CT7-2E1 SERVICE BULLETIN - 72-0024 R00

SB 72-0024 R00 ENGINE - COLD SECTION MODULE (72-30-00) - INTRODUCTION OF
NITRIDED NO. 3 AND NO. 4 ANNULAR BALL/TRILOBE ROLLER BEARINGS

No. 4 Trilobe Roller Bearing, Replacement
Figure 2

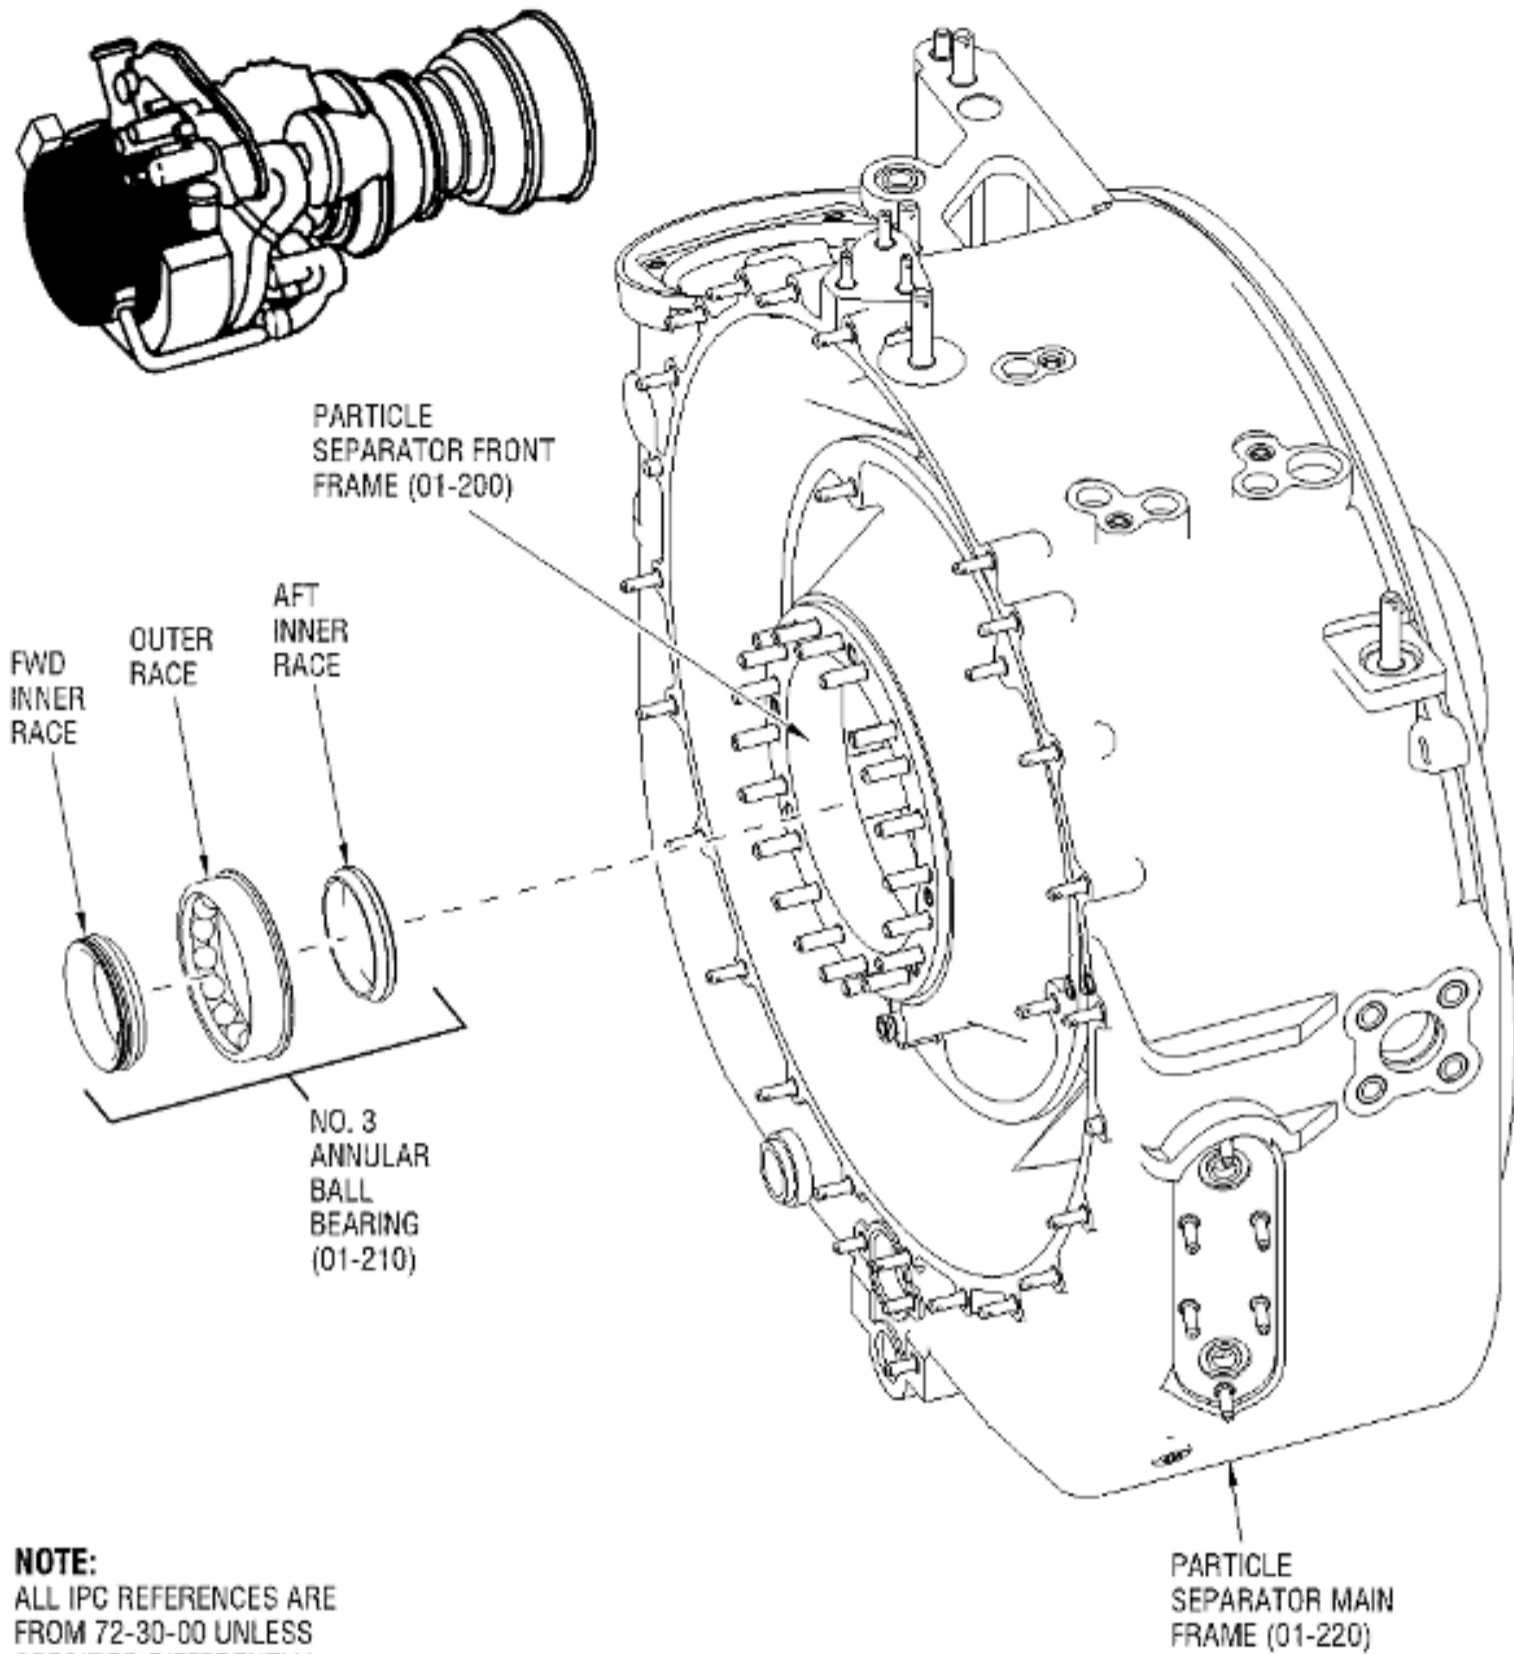
- (1) Remove the installed No. 4 trilobe roller bearing (01-455, 72-30-00) (refer to
- [Figure 2](#)
-) as follows:

- (2) Install the nitrided No. 4 trilobe roller bearing (P/N 5184T21P01) (refer to
- [Figure 2](#)
-) as follows:

No. 3 Annular Ball Bearing, Replacement
Figure 1

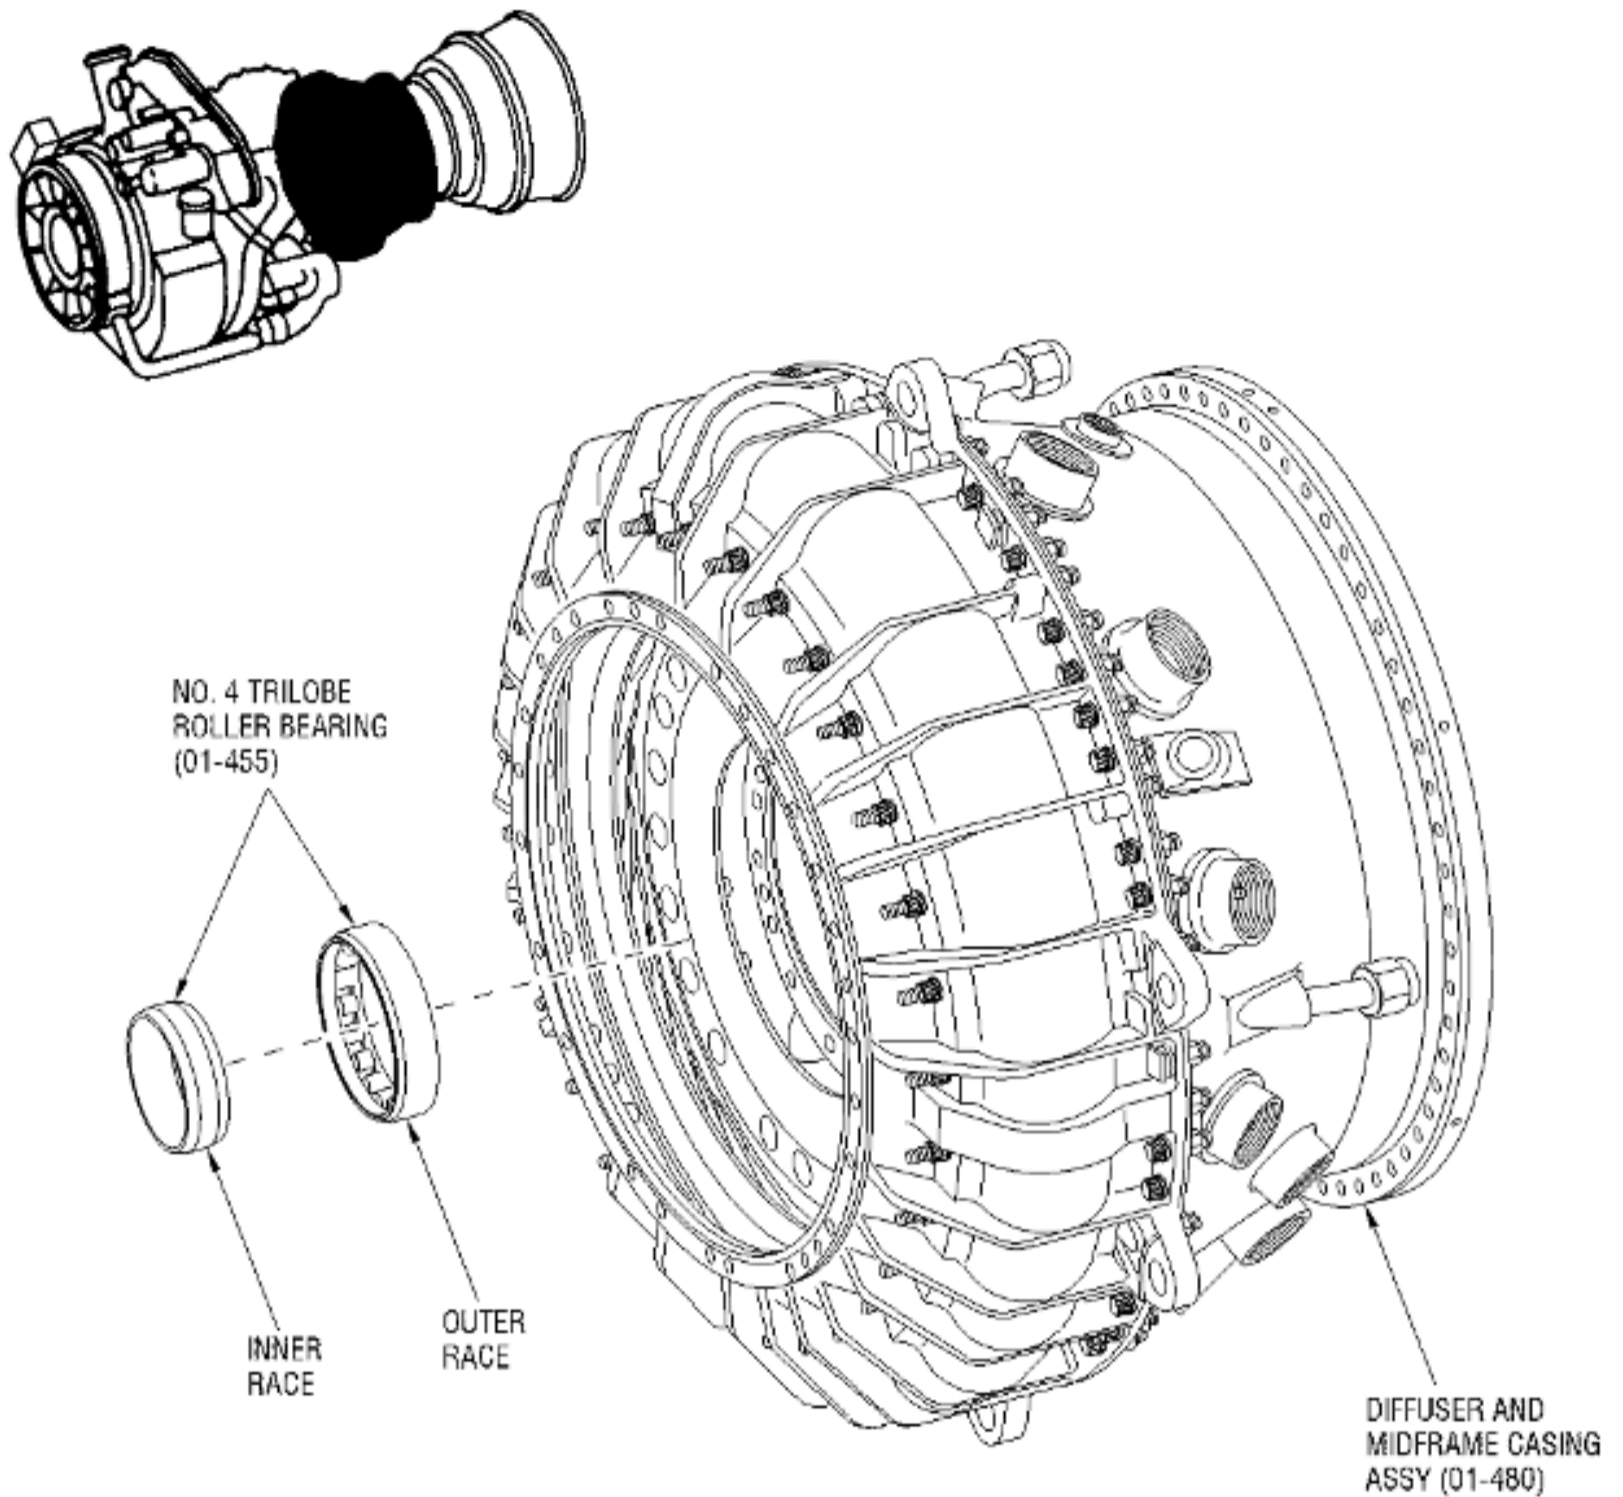
- (1) Remove the installed No. 3 annular ball bearing (01-210, 72-30-00) (refer to
- [Figure 1](#)
-) as follows:

- (2) Install the nitrided No. 3 annular ball bearing (P/N 5184T20P01) (refer to
- [Figure 1](#)
-) as follows:
